TRANS/WP.29/GRRF/2000/20
28 June 2000

Working Party on Brakes and Running Gear (GRRF)

PROPOSAL FOR DRAFT AMENDMENTS TO REGULATION No. 13
(Braking)

Transmitted by the expert from the European Association
of Automobile Suppliers (CLEPA)

Drum brakes see **fig.2A** of this appendix

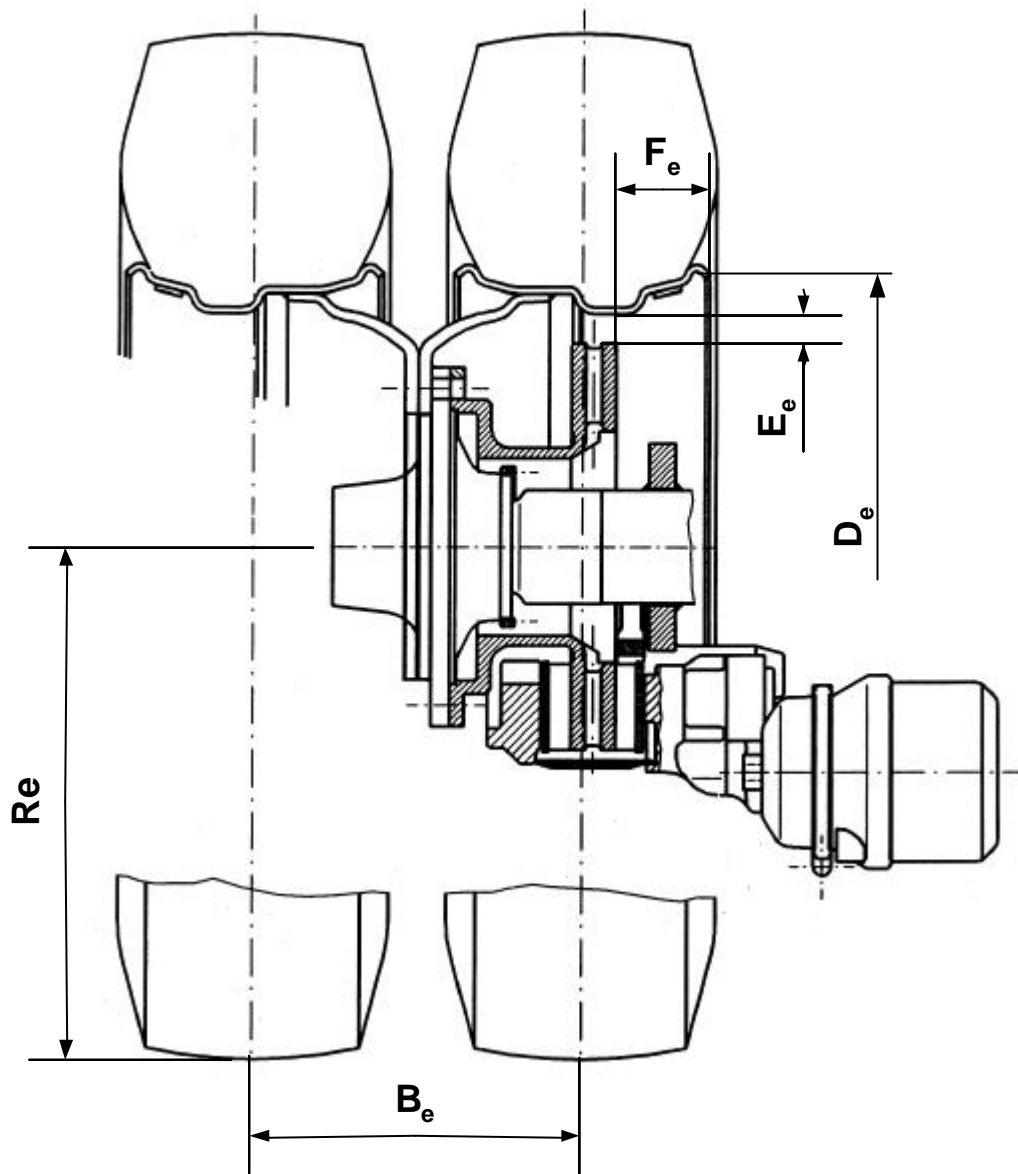
Annex 11 - Appendix 3,

Item 1.2., amend to read (including the footnote 3/):

Brake geometry:

attach dimension drawing as follows:

Disc brakes see fig.2B of this appendix

3/ Applies to disc brakes only"

Figure 2B

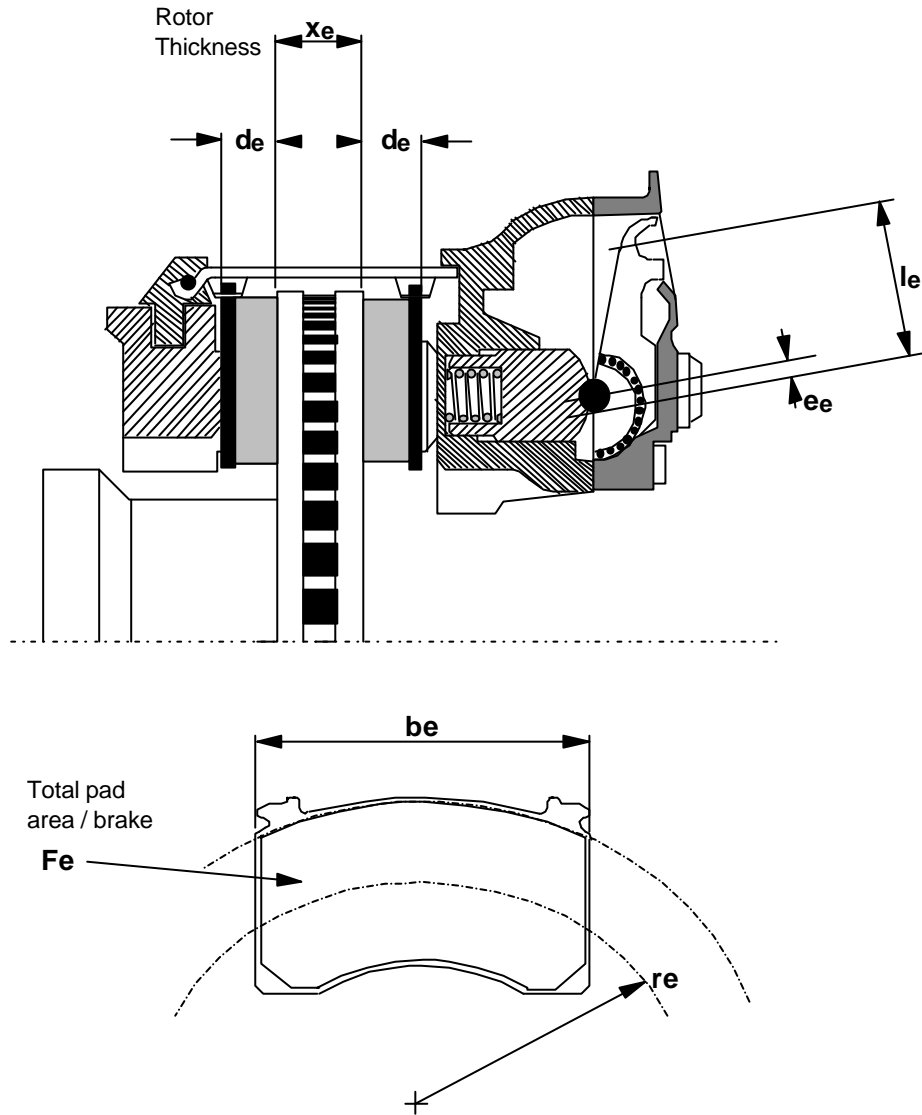
Insert a new Figure 2B for disc brakes, to read:

l_e (mm)	e_e (mm)	d_e (mm)	x_e (mm)	r_e (mm)	b_e (mm)	F_e (cm ²)

DIAGRAM 1

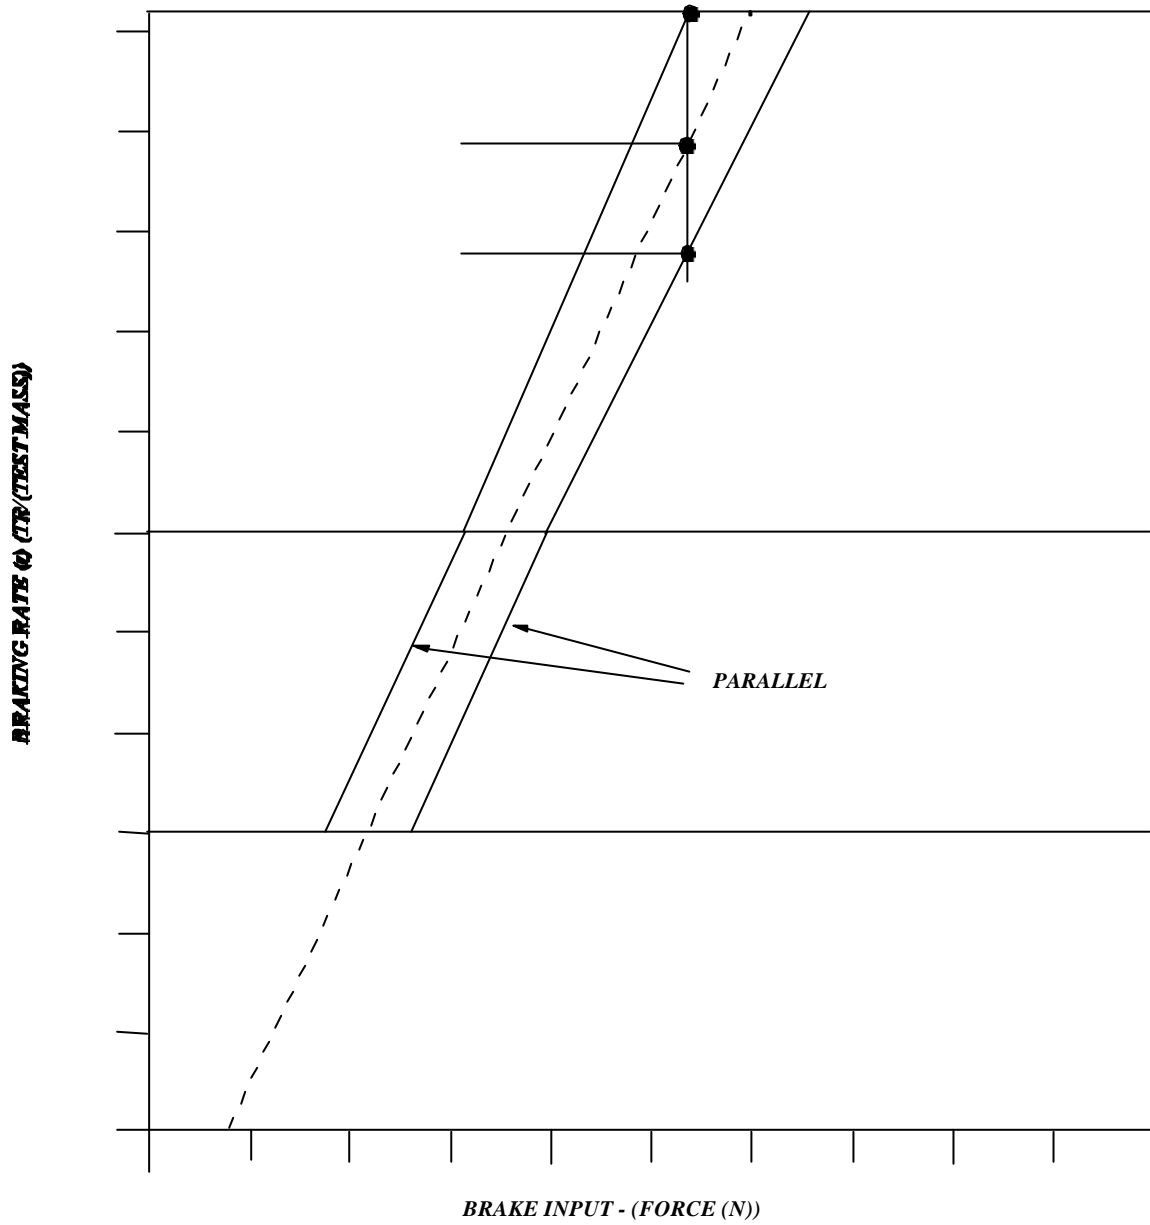
- 4.4.1. Preparation
 - 4.4.1.1. A graph defining the acceptable performance variation shall be constructed, following the model shown in Diagram 1, using the manufacturers declared brake factor.
